This Service Information bulletin supersedes SI 18 05 12 dated June 2012.

Voluntary Emissions Recall Campaign 11E-A03: Check and/or Replace Emissions Monitoring Components

NEW E70 and E90 with the M57Y engine produced from April 2009 to September 2010

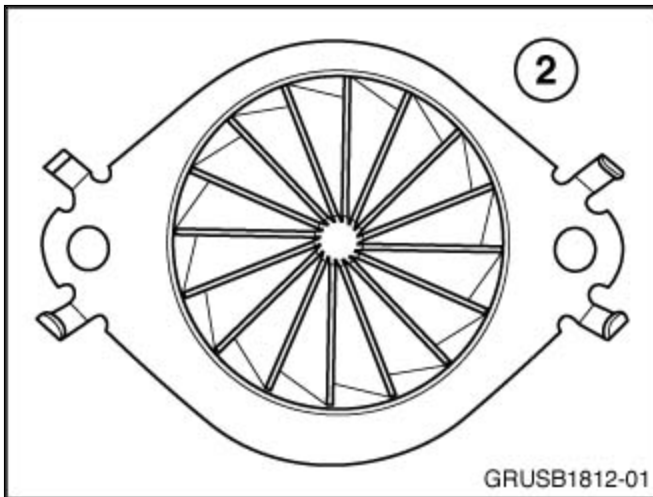
The original style mixer has a multiple fin arrangement (1). This mixer will need to be replaced with P/N 18 30 8 513 445 (E70) or P/N 18 30 8 512 438 (E90).

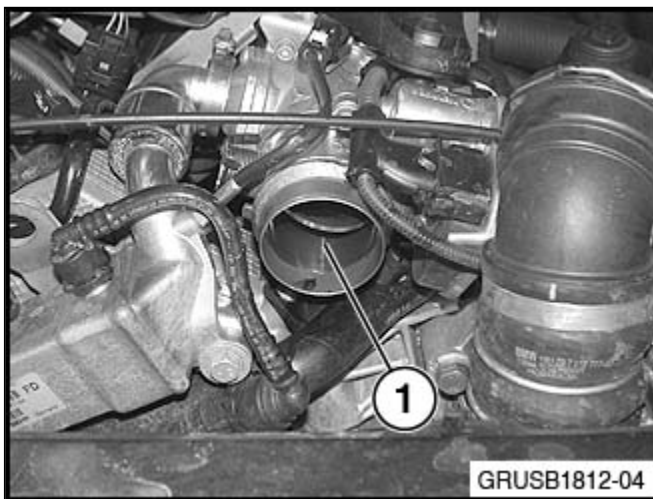
If the updated mixer has already been installed, it will have one set of fins (2). No replacement is necessary. Reinstall

Inspecting the EGR valve:

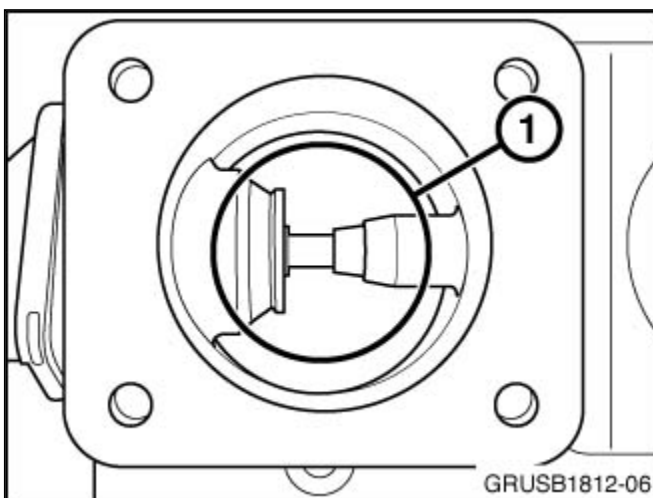
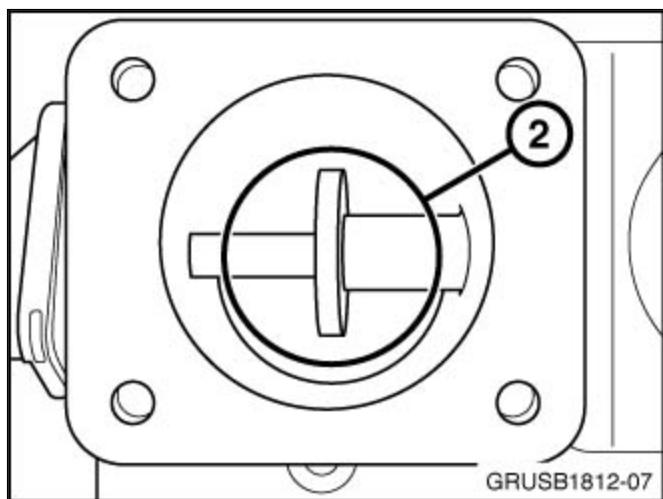
Remove the charge air pipe at the throttle housing (ignition off). Using a flashlight, look through the throttle (1) and inspect the EGR valve.

The updated EGR valve (P/N 11 71 8 517 217 or P/N 11 71 8 512 526) has the valve and seat directly in the airstream of the throttle (1). If this valve is installed, no further action is needed. Reinstall the charge air pipe.

The original EGR valve has a diffuser in the airstream flow from the throttle (2). The valve for EGR actuation is seated further into the EGR airstream. Replace this valve with P/N 11 71 8 512 526 (Repair Instruction 11 71 501).

The DDE will also need to be programmed as part of the Recall. If the EGR valve is replaced, the DDE will need to be programmed after the new EGR valve is installed. This new software package contains the necessary software to adapt to the new EGR valve strategy.
